Re: Amended Plans and Reports

Property: 11 Darius Avenue, North Narrabeen

Development Application: DA2024/1678

Figure 1 – Relationship between the proposed studio and elevated rear yard and boundary fence to 13 Darius Steet.

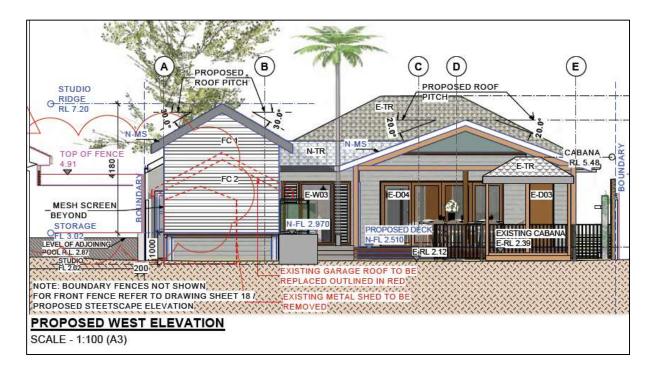
The amended plans have increased the setback of the proposed studios to 3.34m from the rear boundary. The amended plans have reduced the length of the studio from 7.225m to 5.325m reducing the bulk and scale of the proposed studio element.

Additionally, it is noted that the studio structure adjoins an elevated portion of the rear yard at 13 Darius Street and will not result in unreasonable visual bulk and scale impacts to this adjoining property. The level of the rear yard of 13 Darius Street is shown on the west elevation Plan No. 16 with an extract in **Figure 1** below.
